Pre Bid Response & Corrigendum Document

Selection of Agency for Fiber Rollout & Deployment for Creation of OFC Backbone Link In Bastar Division In The State Of Chhattisgarh under BastarNet Project

28/CEO/ CHiPS /BastarNet/ /2016

Pre Bid Response 01/CEO/CHiPS/BastarNet/2016

The Amended Pictorial view and details of Ring and Link is as below

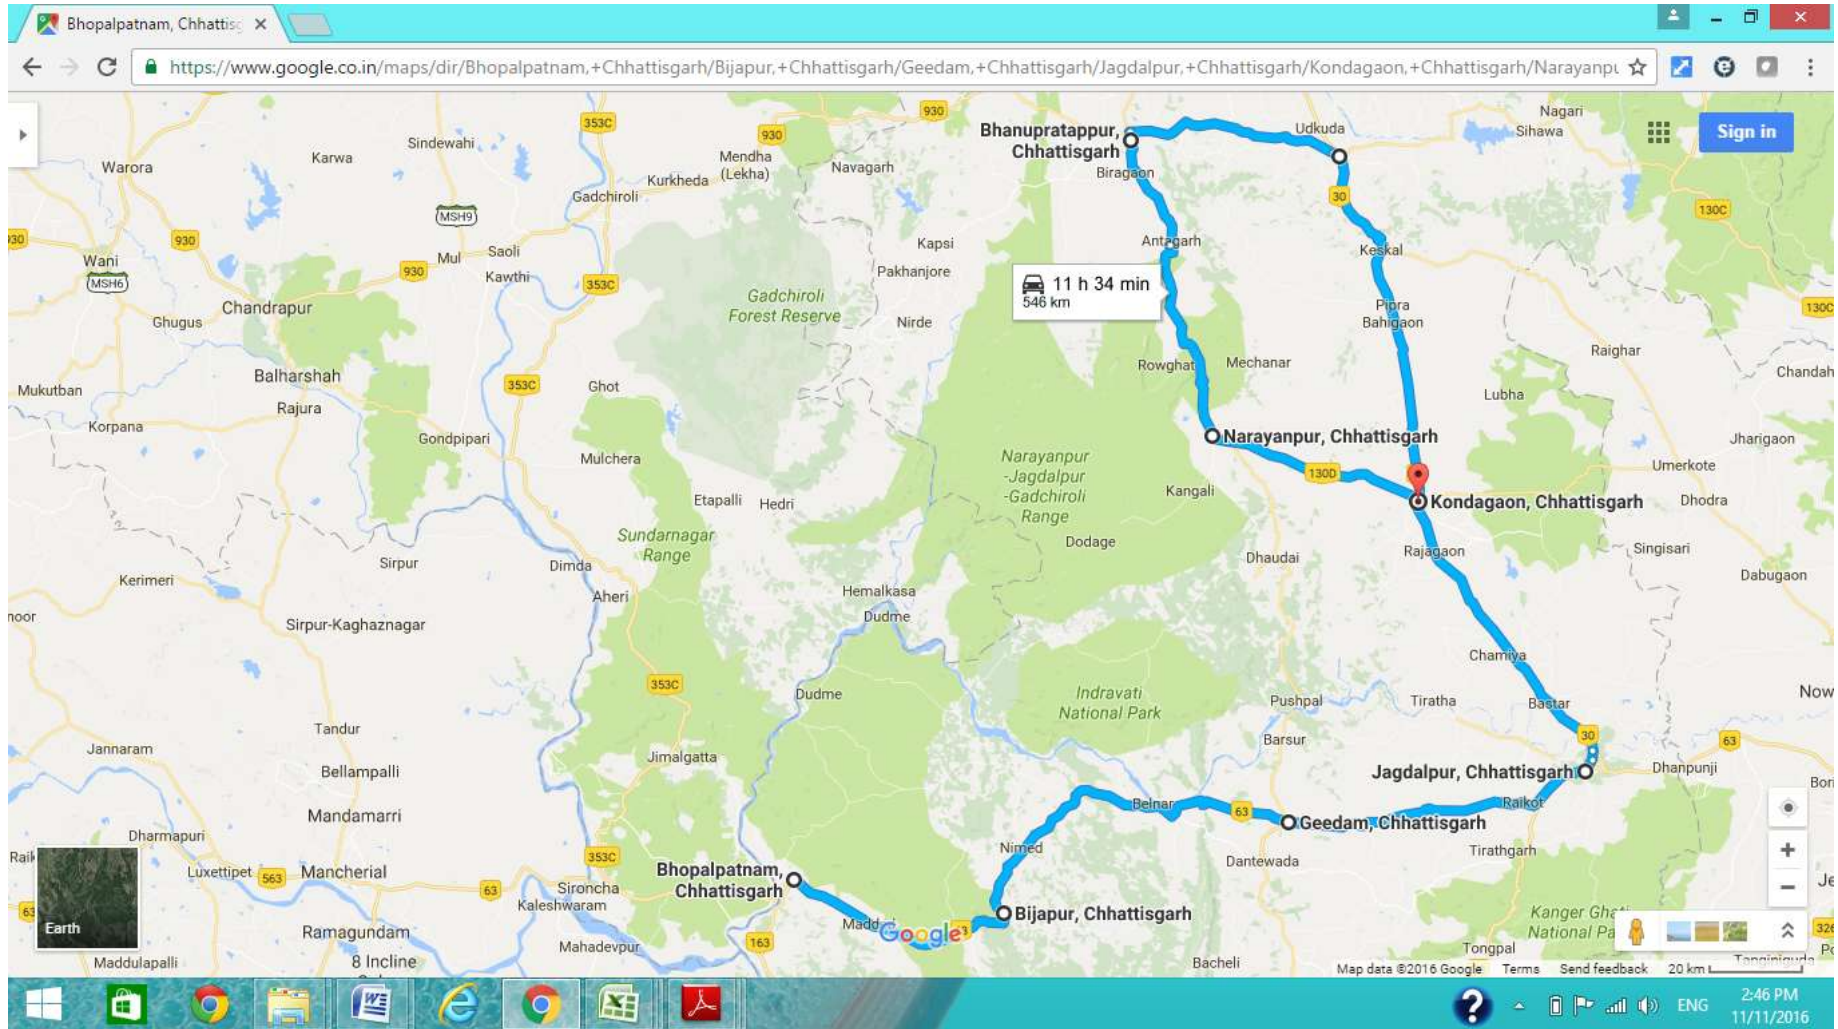
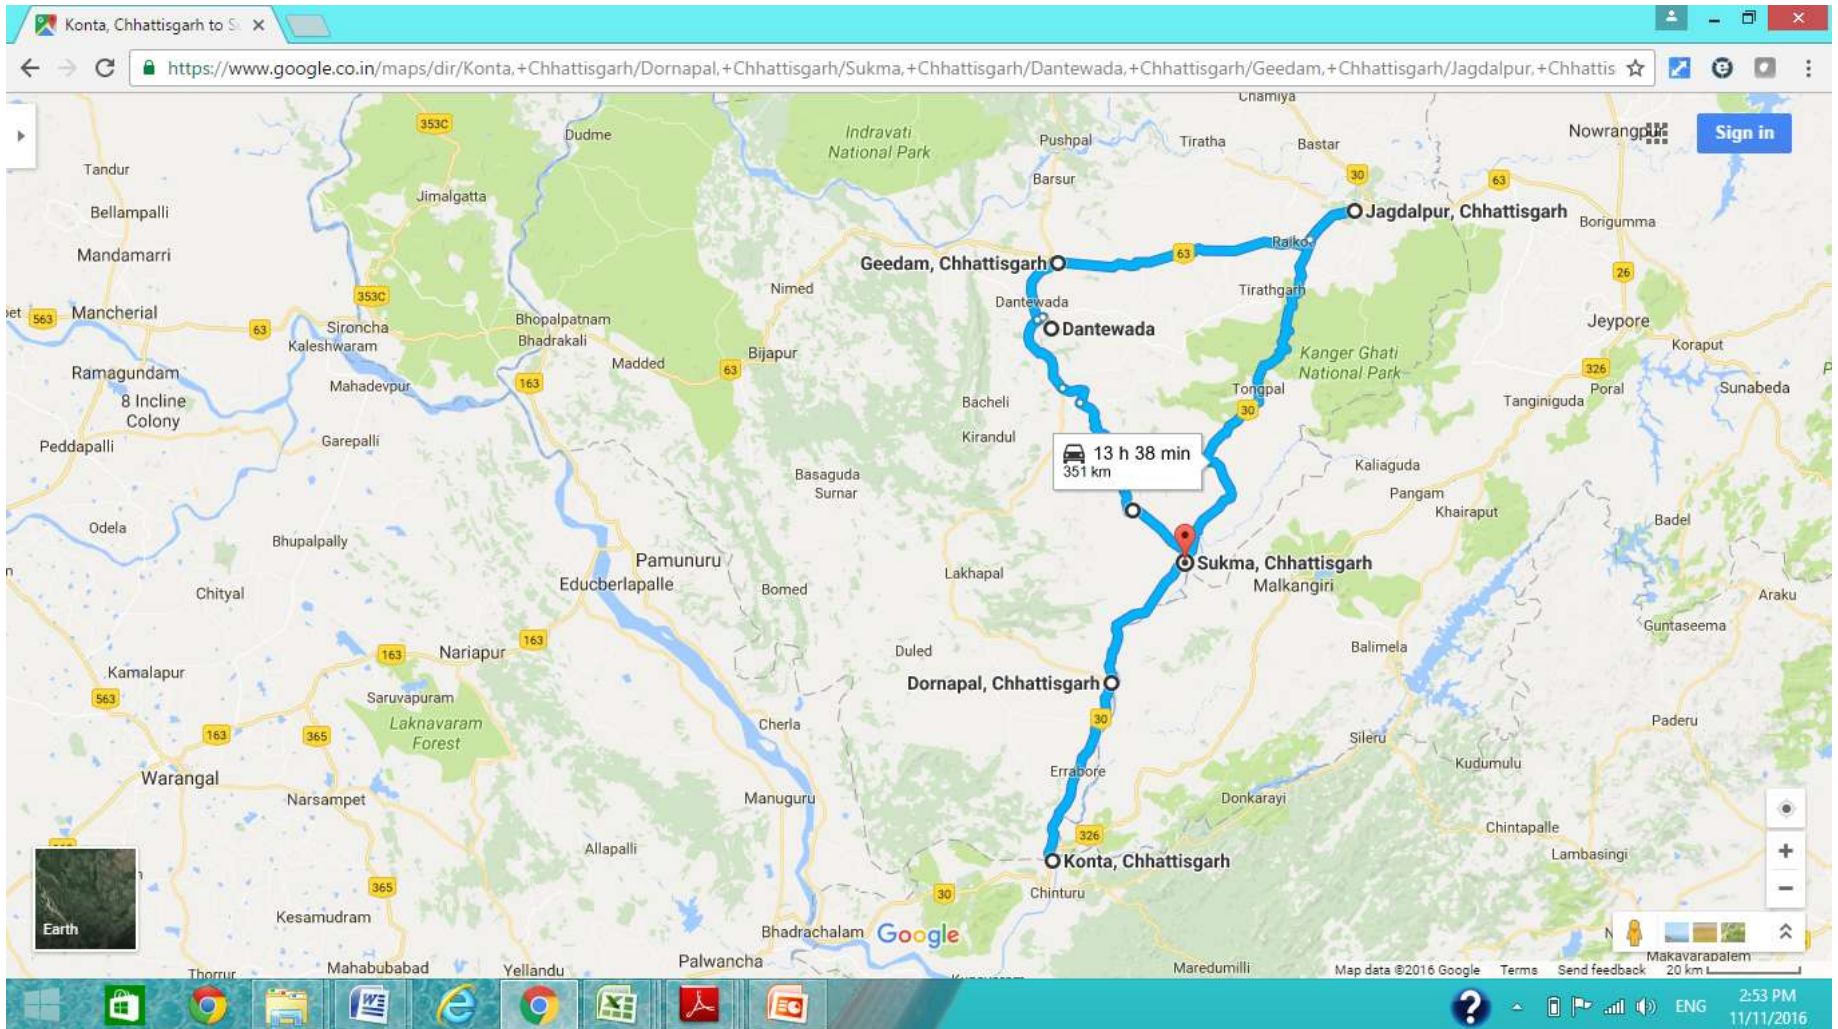
B. The following Addenda are to be read, as mentioned below at **Page no.46, Section 5 under Scope of Work.**

4	Sec-5, Page No.94	4.3	4.3 Optical Fiber Cable & Installation: Type A : Intrusion Proof Fiber Optic Cable [(48F Armoured G.652D)]	Kindly share the cable construction specifications of 48 F Armoured Optic Cable	Please read Corrigendum
5	Sec-5, Page No.94	4.5	4.5 Overhead ADSS Aerial Cable: Minimum Specification: 48 Core Optical Fiber G.652 D. ADSS Cable	Kindly share the cable construction specifications of 48 F ADSS Cable	Please read Corrigendum
6	Sec-5, Page No. 46 & 47		Underground OFC Laying in Ring 1 (Page 46) & The following are the pictorial view and details of Ring and Link wise installation and commissioning required under this project (Page 46)	Links Geedam to Bijapur and Bijapur to Bhopalpatnam are shown pictographically (page 47) under Ring-1 and are described as Link 11 and Link 12 under Ring 2, Kindly clarify whether Link 11 and Link 12 come under Ring 1 or Ring 2 ??	Pictorial View is wrong, please find corrected pictorial View for reference in Corrigendum

Ring 1:

Ring 2 :

Note: Jagdalpur to Geedam OFC laying Link will be complete by Ring 1 Bidder.
